Access Compliance Report Public Rights-of-Way (Curb Ramps)

Main Street: YORBA_ST Cross Street: ROMELLE_AVE Location: SW

ADA ID: RPRK220126121753 Ramp Type: Type 1 - Perpendicular Diagonal Initial Pass/Fail: Fail Overall Compliance: No Severity Score: 15

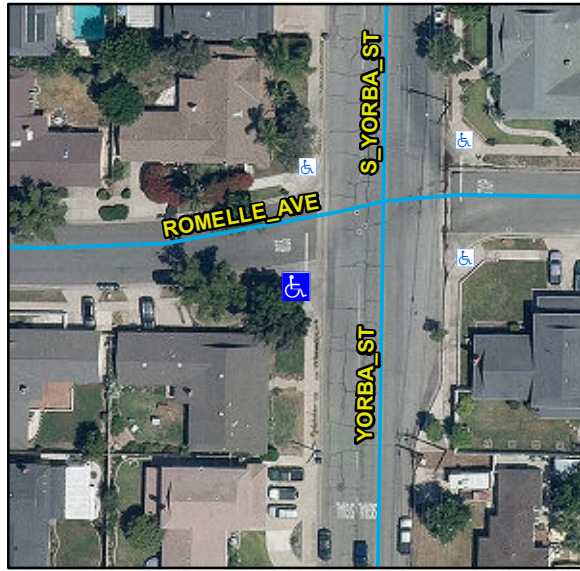
Compliance	Description	Data	Compliance	Description	Data
N/A	Ramp Length (in)	76	N/A	Flare Type LT	
Yes	Ramp Width (in)	54			N/A
No	Ramp Run Slope (%)	9.8	N/A	Flare Slope LT (%)	N/A
Yes	Ramp Cross Slope (%)	1.8	N/A	Flare Traversable LT	N/A
N/A	Landing Present	N/A	N/A	Flare Type RT	
N/A	Landing Length (in)	N/A			N/A
N/A	Landing Width (in)	N/A	N/A	Flare Slope RT (%)	N/A
N/A	Landing Run Slope (%)	N/A	N/A	Flare Traversable RT	N/A
N/A	Landing Cross Slope (%)	N/A	N/A	DWS Provided	N/A
N/A	Landing Movement Obstructed?	N/A	N/A	DWS Contrast	N/A
	Landing Movement Type	N/A	N/A	DWS Length (in)	N/A
N/A	Landing Shared	N/A	N/A	DWS Full Width	N/A
N/A	Clear Space	Yes	N/A	DWS Offset Left (in)	N/A
N/A	Clear Space To Crosswalk (in)	N/A	N/A	DWS Offset Right (in)	N/A
N/A	Marked Crosswalk 1	No	N/A	Marked Crosswalk 2	No
	Crossing 1 Direction	E		Crossing 2 Direction	N
	Marked Crosswalk 1 Width (in)	N/A		Marked Crosswalk 2 Width (in)	N/A

Remove & Replace Curb Ramp With Two New Directional Ramps or Equivalent.
